UNITED STATES PATENT AND TRADEMARK OFFICE

APPLICATION NO.	FILING DATE	FIRST NAMED INVENTOR	ATTORNEY DOCKET NO.	CONFIRMATION NO.
09/980,106	04/09/2002	Anton Scholten	VER-153 XX	1182
207	7590	10/16/2003	EXAMINER	
WEINGARTEN, SCHURGIN, GAGNEBIN & LEOVICI LLP TEN POST OFFICE SQUARE BOSTON, MA 02109			ALEJANDRO, RAYMOND	
			ART UNIT	PAPER NUMBER
			1745	7

Office Action Summary	Applicant No .	Applicant(s)
	09/980,106	SCHOLTEN ET AL.
	Examiner Raymond Alejandro	Art Unit 1745

DETAILED ACTION

Fig.1

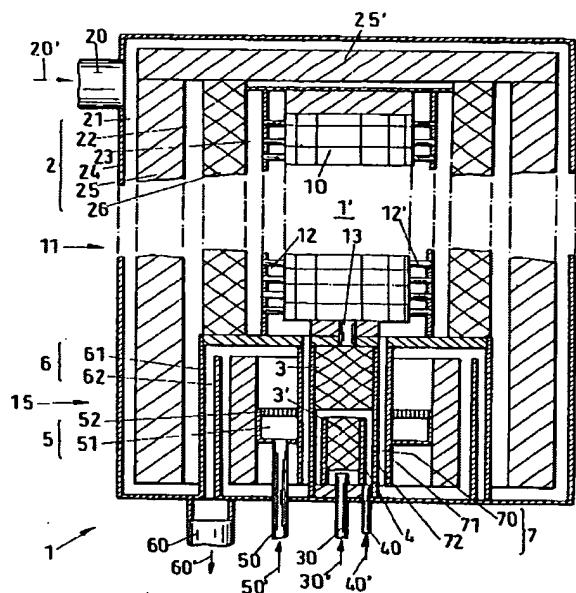
Figure 1 below shows fuel cell 10 wherein the fuel cell has the specific inlet features connecting the fuel cell and the reformer, and for supplying air; and the specific outlet features for discharging both the unburned gas and the unused air therefrom.
